ADDENDUM NO.: 04

DATE OF ADDENDUM: July 31, 2015

**INTERIOR RENOVATIONS/IMPROVEMENTS  
OFFICE OF POLICY AND MANAGEMENT  
450 CAPITOL AVENUE  
HARTFORD, CT  
BI-2B-385**

SKA-1

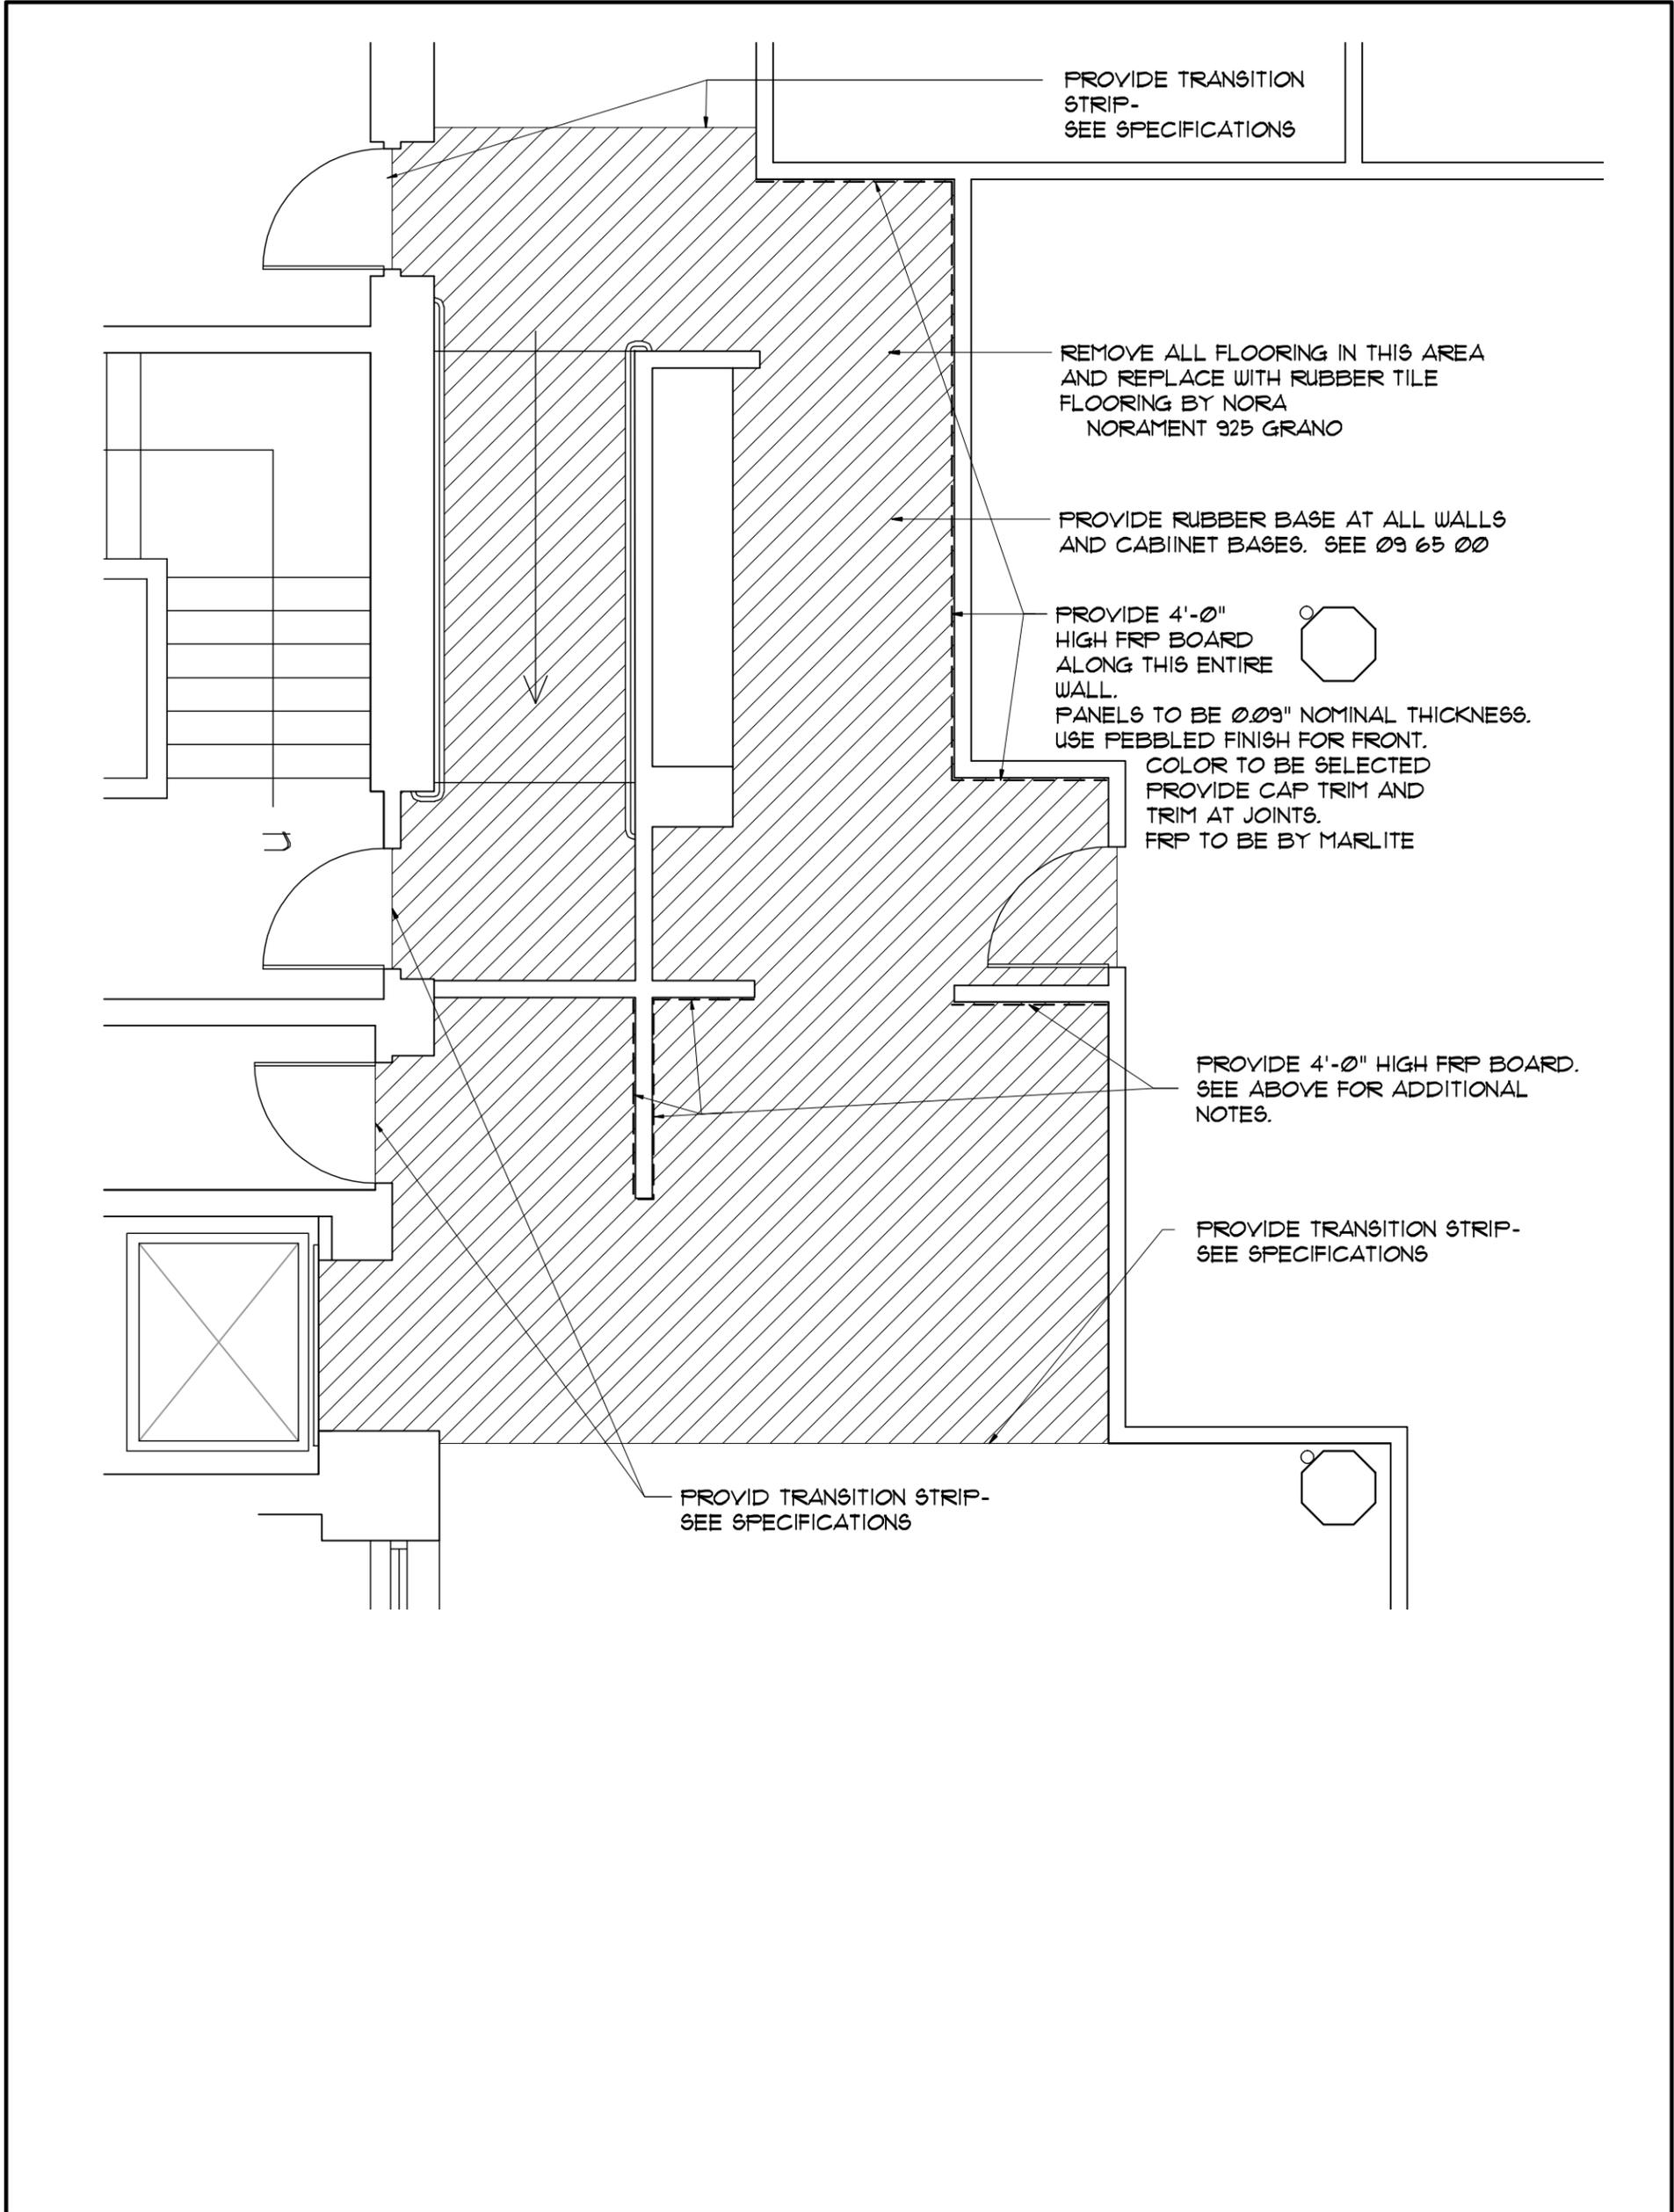
On **DRAWINGS** A-103a, Third Floor Plan Floor Finishes; A-103b, Third Floor Plan Painting Finishes.

**REVISE:** Add/Revise Flooring and Wall Finishes per attached sketch "REVISED" SKA-1, dated 7/30/2015 (Please note: Sketch is 11" x 17" Format).
